IEEE 802.3
Interpretations Report

March 18th, 2004

Interpretation Number: 1-03/04
Topic: Functions: Check_end
Relevant Clause: 48.2.6.1.4
Classification:

Figure 48-9—PCS receive state diagram

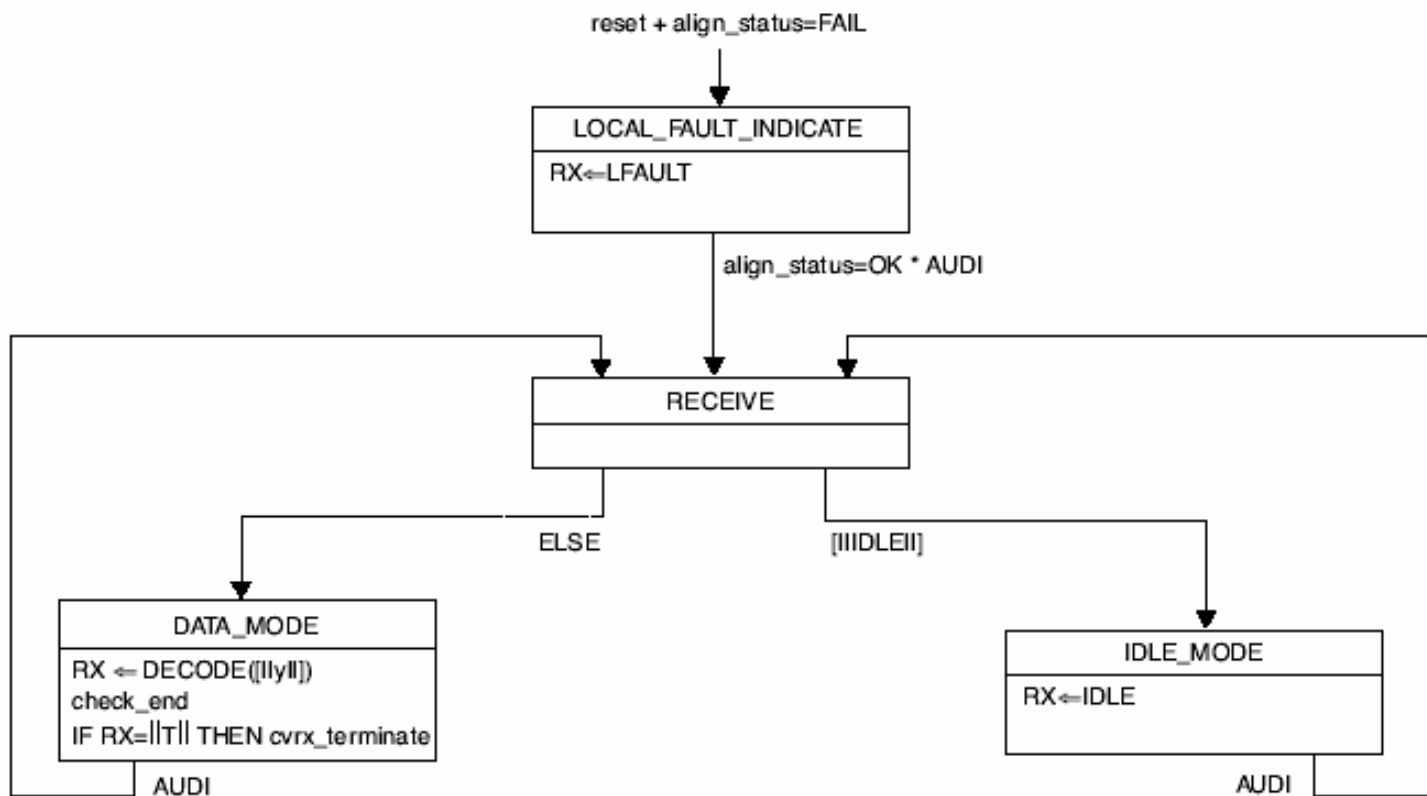
The XGMII Error control character is returned in all lanes less than n in the ||T||, where n identifies the specific Terminate ordered-set ||Tn||, for which a running disparity error or any code-groups other than /A/ or /K/ are recognized in the column following ||T||.

Query:-

Please refer to situation below.

In the above situation, the column C is the mix of /A/ and /K/.

What should be the resulting XGMII code groups?.

In this case, the Check_end function does not take any action. Columns A and B are sent with the same characters that they received. Therefore the XGMII Code Groups sent will be:

Explanation, on all lanes less than n in the ||T||, the code-group in the following column is /A/. Therefore, there are not lanes in the ||T|| meeting the criteria "...less than n ... for which a running disparity error or any code-groups other than /A/ or /K/ are recognized in the column following the ||T||." Note that the Check_end function only requires that the next character in the lane be checked, so the answer would be the same even if there were multiple lanes less than n which had a mix of /A/ and /K/ in column C (see supplementary example).

Note also that Column C does not fit the definition of ||I|| so it is sent to the XGMII as received. It is not converted to // characters.
